RE: Oven Mountain Pumped Hydro – EIS (SSI – 12422997)

BCD has reviewed the EIS dated August 2023 and the Biodiversity Development Assessment Report (BDAR) dated September 2023, both prepared by EMM, as well as other associated documents. BCD staff also completed a site inspection on 19 and 20 April 2023. The advice below builds on the advice BCD provided to EMM following our review of the draft EIS, draft BDAR and associated documents.

Attachment 2: Detailed BCD Comments – Oven Mountain Pumped Hydro – Environmental Impact Statement

Figure 2. Extract from figure 6.1, Map 2 of 8 of BDAR showing targeted flora survey effort with red circles added to indicate examples of unsurveyed 100m grid intersection locations.

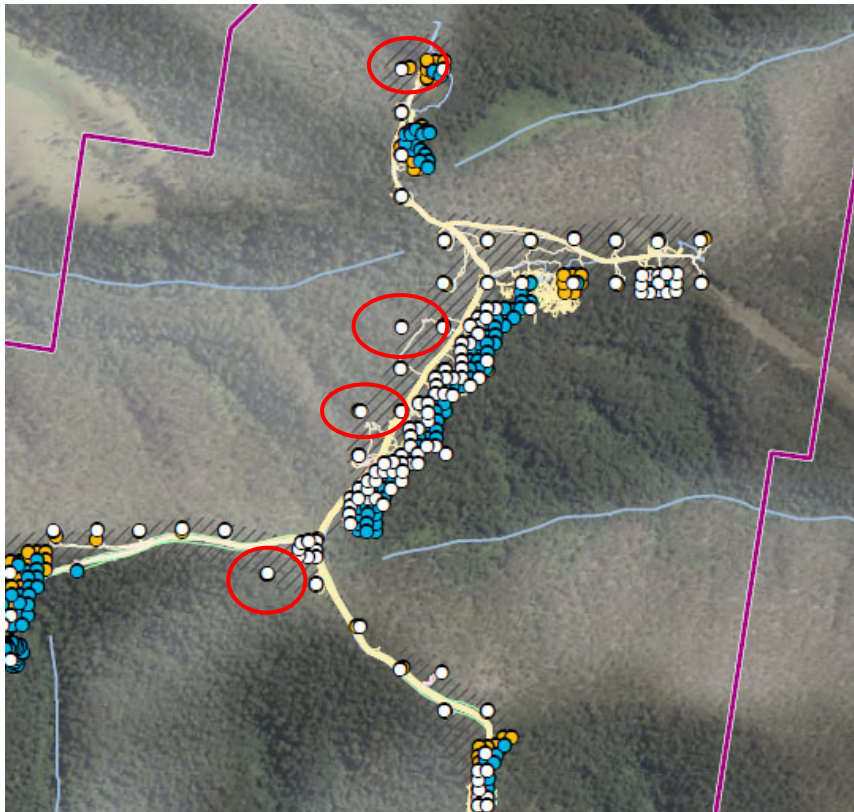
However, some of the grid intersections requiring survey in maps 2 and 4 of Figure 6.1, do not appear to have been surveyed, as shown in Figures 2 and 3 below.

- 7.1 The BDAR be revised to determine the presence of candidate threatened flora species in all areas of unsurveyed 100 metre (m) grid intersection locations by surveying, by assuming presence or by obtaining an expert report.
